42942A-01

S E R V I C E N O T E

42942A Terminal Adapter, 40 Hz to 110 MHz

This service note provides the updated part numbers and figures for both RoHS and non-RoHS 42942A Terminal Adapter, 40 Hz to 110 MHz

**Figure 1-1**

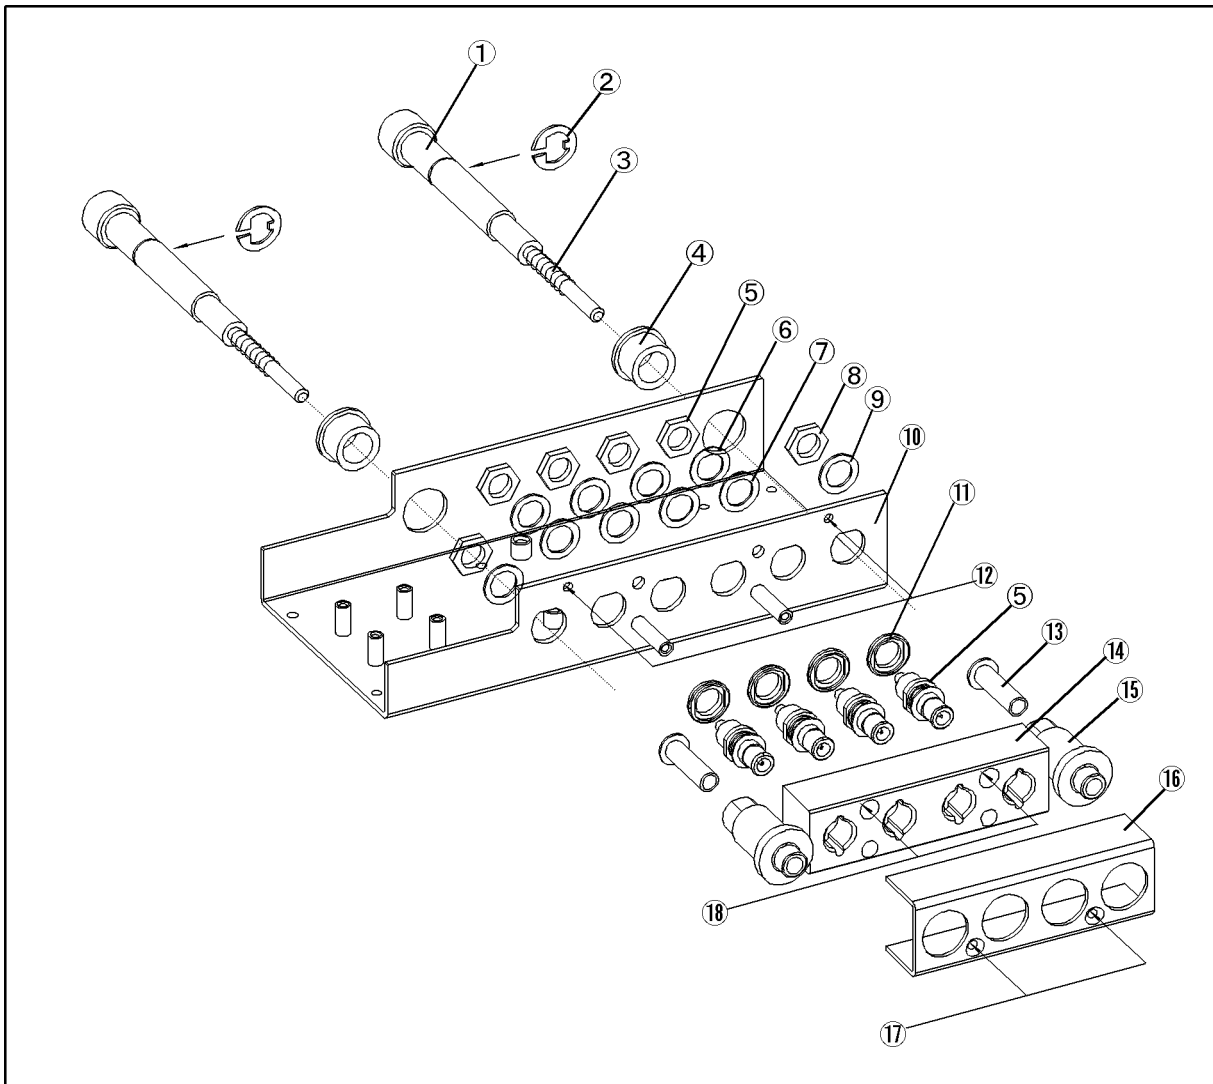
Shown are the support parts for RoHS and non-RoHS compliance 42942A Terminal Adapter, 40 Hz to 110 MHz. All the listed items are changed at RoHS conversion. Due to limited availability of RoHS compliance station and technical difficulties in RoHS soldering, only parts and support level that do not require RoHS soldering are supported. Shown are the supported RoHS compliance parts for 42942A Terminal Adapter, 40 Hz to 110 MHz.

NOTE: For RoHS Compliant Upper Level Assembly Replacement Part, if multiple parts are replaced by a common higher assembly part, only order ONE part of the higher level common assembly.

Ref/ D	Part Number	Description	Qty.	RoHS Compliant Replacement Part	Description	Qty.
1	42942-24007	SHAFT	2	42942-24007	SHAFT	2
2	0510-0083	RTNR-R	2	0510-0083	RTNR-R	2
3	1460-2615	SPRING	2	1460-2615	SPRING	2
4	42941-40002	BUSHING	2	42941-40002	BUSHING	2
5	1253-0476 (5012-8630)	ADPT BNC-SMB	4	5012-8630	ADPT BNC-SMB	4
6	3050-0067	WSHR-FL MTLC	4	3050-0067	WSHR-FL MTLC	4
7	3050-0789	WSHR-FL NM	4	3050-0789	WSHR-FL NM	4
8	2950-0054	TNUT-HEX-DBL- CHAM	2	2950-0054	TNUT-HEX-DBL- CHAM	2
9	2190-0054	WSHR-LK INTL	2	2190-0054	WSHR-LK INTL	2
10	42942-00602	COVER BOTTOM	1	42942-00602	COVER BOTTOM	1
11	16047-40002	INSULATOR	4	16047-40002	INSULATOR	4
12	0515-0914	SCR-MACH M3X0.5	2	0515-1946	SCR-MACH M3X0.5	2
13	42941-25002	SLEEVE	2	42941-25002	SLEEVE	2
14	42942-25006	BNC-GUIDE	1	42942-25006	BNC-GUIDE	1
15	42941-24003	GUIDE	2	42941-24003	GUIDE	2
16	42942-00603	COVER	1	42942-00603	COVER	1
17	0515-0914	SCR-MACH M3X0.5	2	0515-1946	SCR-MACH M3X0.5	2

18	0515-1551	SCR M3-L 10 P-H	2	0515-0372	SCR M3-L 10 P-H	2

Figure 1-2

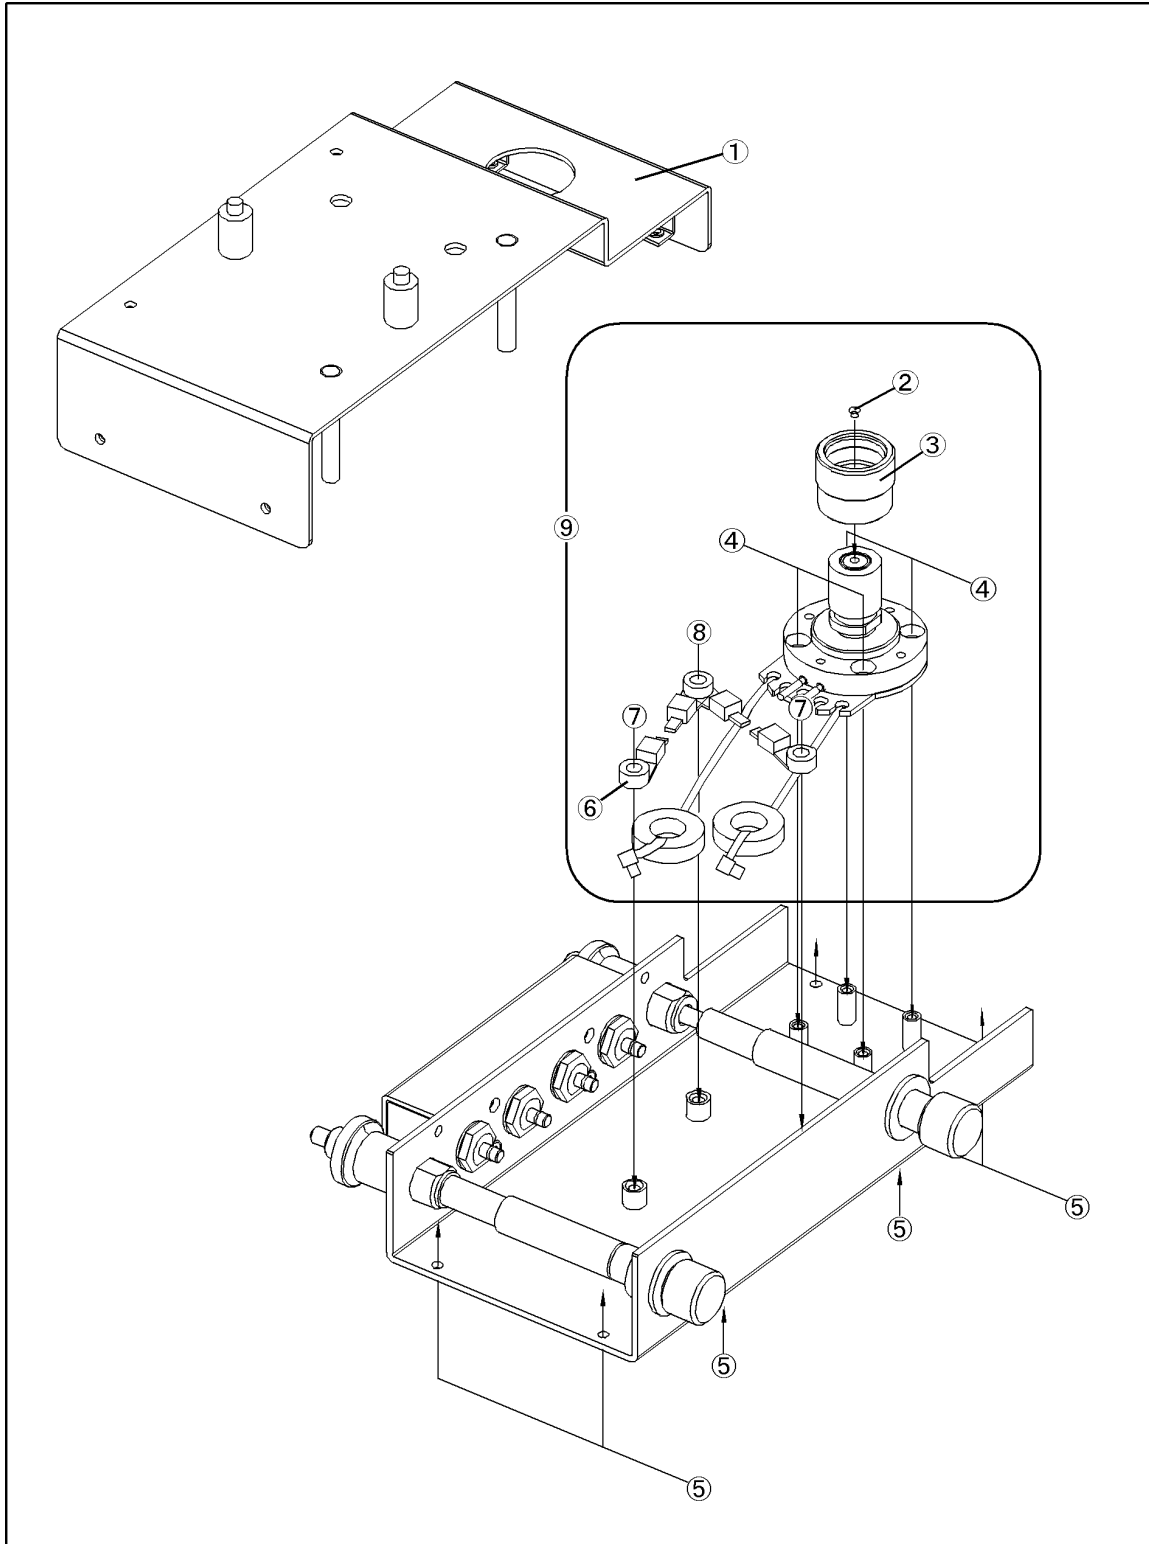
Table 1-2: Replaceable Part (Part 2 of 2)

Ref/ D	Part Number	Description	Qty.	RoHS Compliant Replacement Part	Description	Qty.
1	42942-00601	COVER TOP	1	42942-00601	COVER TOP	1
2	1250-0907	CONTACT CENTER	1	1250-0907	CONTACT CENTER	1
3	1250-1466	CONN-RF 7mm	1	1250-1466	CONN-RF 7mm	1
4	0515-1550	SCR M3-L 8 P-H	4	0515-0372	SCR M3-L 8 P-H	4
5	0515-0914	SCR-MACH M3X0.5	6	0515-1946	SCR-MACH M3X0.5	6
6	1400-0719 (1400-3284)	CABLE TIE	4	1400-3284	CABLE TIE	4
7	0515-1719 (0515-1718)	SCR M4X10(X12)	2	0515-0382	SCR M4X10(X12)	2
	3050-0893	WSHR-FL	2	3050-0893	WSHR-FL	2
8	0515-1718 (0515-0868)	SCR M4X12(X16)	1	0515-0383	SCR M4X12(X16)	1
	3050-0893	WSHR-FL	1	3050-0893	WSHR-FL	1
9	42942-60001	7mm ASSY (exclude 4.6.7.8)	1	42942-60601	7mm ASSY (exclude 4.6.7.8)	1
